# UNITED STATES PATENT AND TRADEMARK OFFICE

APPLICATION NO.	FILING DATE	FIRST NAMED INVENTOR	ATTORNEY DOCKET NO.	CONFIRMATION NO.
10/777,950	02/12/2004	Tommy Rodrigues	FDN-2797	7092
7590	09/29/2006		EXAMINER [REDACTED]	GILBERT, WILLIAM V
			ART UNIT [REDACTED]	PAPER NUMBER 3635
			DATE MAILED: 09/29/2006

**DETAILED ACTION**

**Figure 5 from Bondoc**

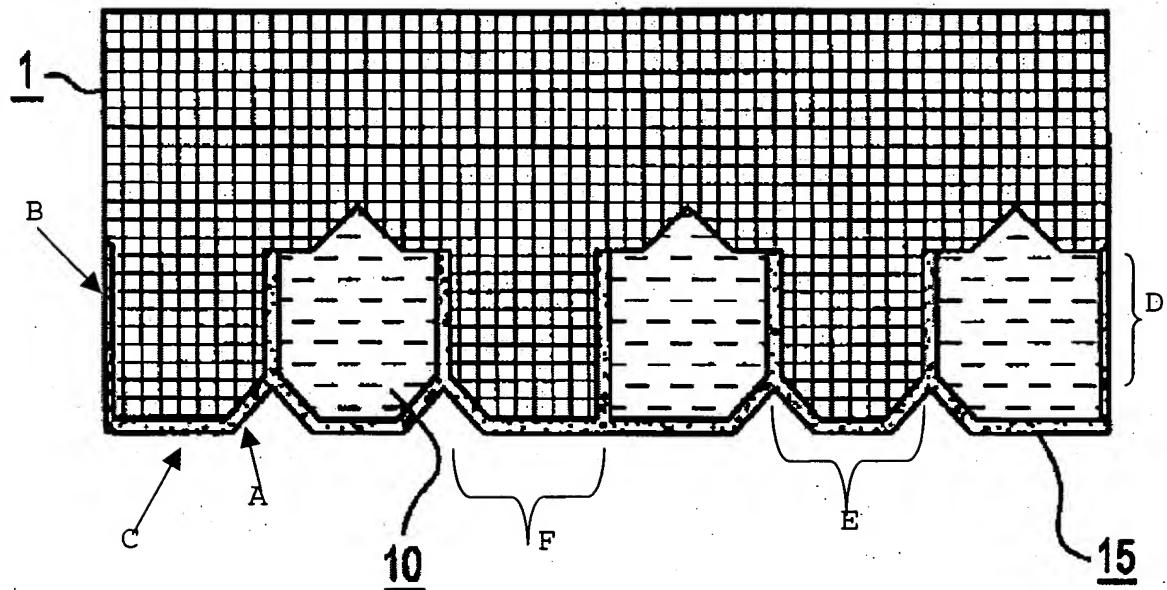
Regarding Claims 1, Bondoc discloses a shingle (Figure 5, generally) having a head lap (Figure 1, element 3) and a butt (Figure 1, element 4), an alignment notch (Figure 1, element 6) and at least one corner corresponding to the notch (element "A" from attached Figure 5 from Bondoc, below).

Regarding Claim 3, the notch (6) has a triangle shape and a corner corresponds to a side of the triangle (element "A" from attached Figure 5 from Bondoc, above).

Regarding Claim 5, the anterior layer has at least one alignment notch (6) and the posterior layer has at least one corner corresponding to the alignment notch (element "A" from attached Figure 5 from Bondoc, above).

Regarding Claims 8, 29, 34, 35 and 52), Bondoc discloses a shingle with at least one layer (per Claim 29), a posterior layer (15, per Claims 8, 34, 35, 52) with a head lap (element "B" from attached Figure 5 from Bondoc, above, per Claim 8, 52) and tabs (element "C" from attached Figure 5 from Bondoc, above, per Claim 8, 52), an anterior layer positioned on the posterior layer (1, per Claims 8, 34, 35, 52), an anterior head lap (Figure 1, element 3, per Claims 8, 35, 52), an alignment notch (Figure 1, element 6, per Claims 8, 35, 52) and at least one anterior tab (Figure 1, element 2) positioned on the posterior tabs (per Claims 8, 52). The phrases "formed from...length", per Claim 29, line 1, "formed from...layer", per Claim 34 line 3 and "formed form...length" per Claim 35, line 3, "formed from...layer" per Claim 52 line 3 are statements of the process of making the claimed invention and must result in a structural difference between the claimed invention and the prior art in order to patentably distinguish the claimed invention from the prior art. If the prior art structure is capable of being made in this manner, then it meets the claim.

Regarding Claim 25, the anterior tab (2) has a corner that corresponds to the alignment notch (see area proximate element A from attached Figure 5 above).

Regarding Claim 26, the posterior tabs (element "C" from attached Figure 5 from Bondoc, below) have corners (areaq proximate "A" above) that correspond to the alignment notch (6).

Regarding Claim 27, the anterior tab is positioned substantially centered on the posterior tab (element "E" from attached Figure 5 from Bondoc, above).

Regarding Claim 28, the anterior tab is positioned offset form the posterior tab (element "F" from attached Figure 5 from Bondoc, above).
